6-12 Peters Avenue, Wallsend  
NSW – LAHC Residential Flat  
Building Development

**Access Review –  
Final v4 - Part 5**

8 August 2022

Figure 2. Ground - Accessible Entry Points

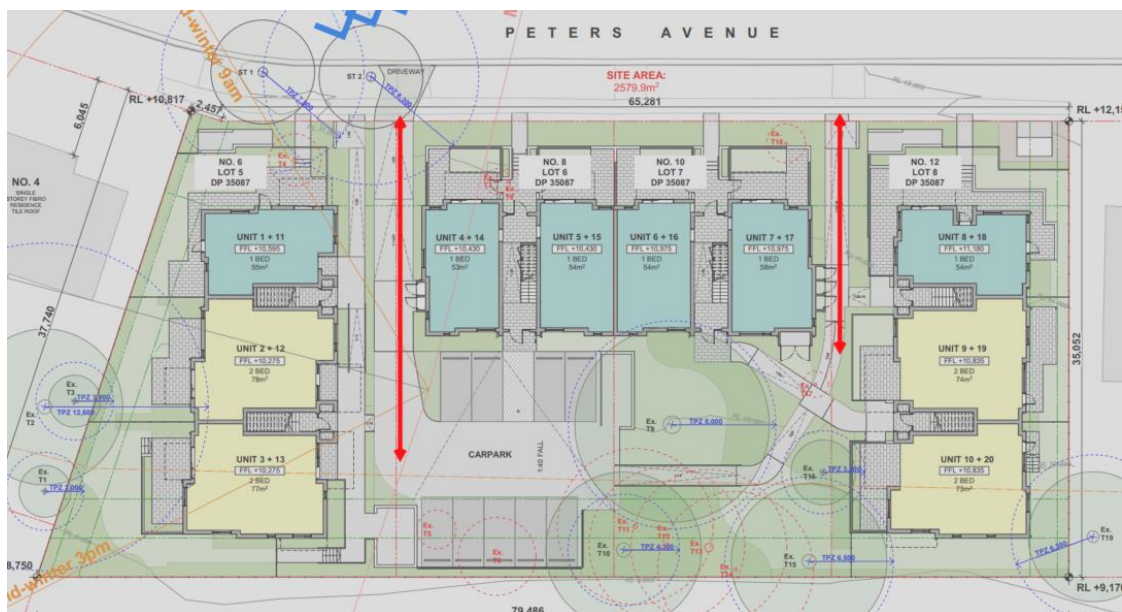
- It will be necessary to provide an accessible path of travel from main pedestrian entry points at the site allotment boundary to all building entrances compliant with AS1428.1:2009. There are two main accessible entrances show below with a red arrow via Peters Avenue. These are capable to achieve provide compliance with AS1428.1.

Figure 3. Ground - Buildings Links

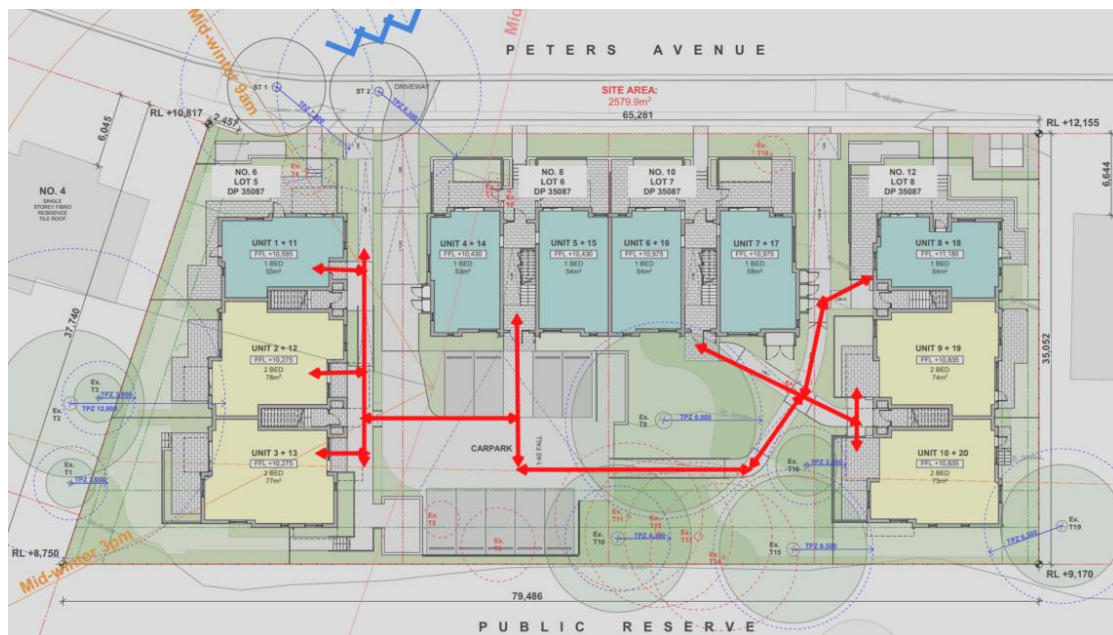
- An accessible path of travel between buildings (or parts of buildings) that are connected by a pedestrian linkage, within the site allotment boundary, compliant with AS1428.1:2009 is also required. Currently, this requirement has been achieved as access connection is via car parking on both directions.
